Economic and Social Council

Proposal for Amendment 1 to gtr No. 5 (Worldwide Harmonized Heavy Duty On-Board Diagnosis Systems (OBD))

Submitted by the Working Party on Pollution and Energy*

"Figure 4

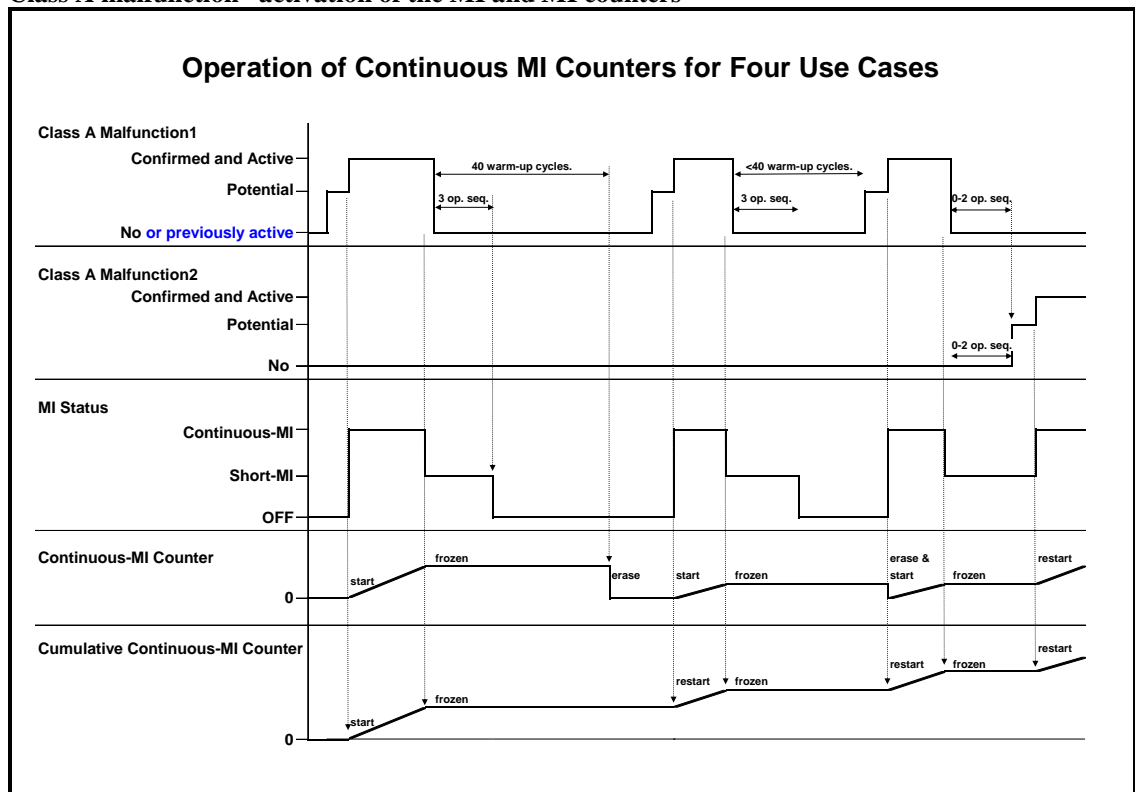
Figure 4, amend to read:

Class A malfunction –activation of the MI and MI counters

Note: Details related to the deactivation of the continuous MI are illustrated in figure 4bis below in the specific case where a potential state is present."

"Figure 4bis

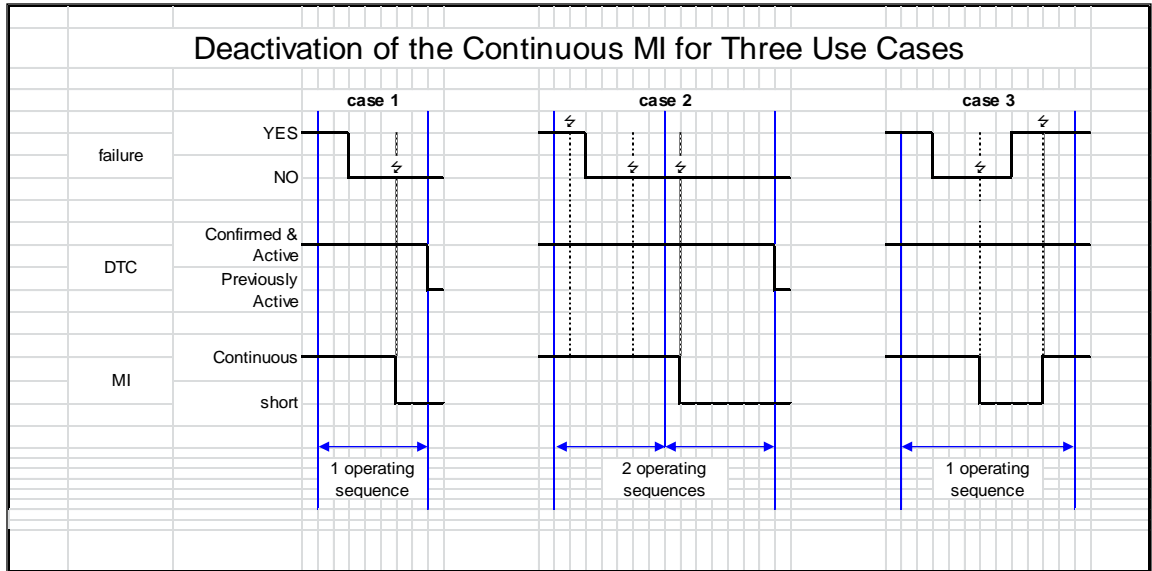
Insert a new figure 4bis, to read:

Illustration of the continuous MI deactivation principle

M means the operating sequence when the monitor concludes for the first time that a confirmed and active failure is no longer present.

case 1 means the case where the monitor does not conclude the presence of failure during the operating sequence M.

case 2 means the case where the monitor has previously concluded, during the operating sequence M, the presence of the malfunction.

case 3 means the case where the monitor concludes, during the operating sequence M, the presence of the malfunction after having first concluded to its absence."
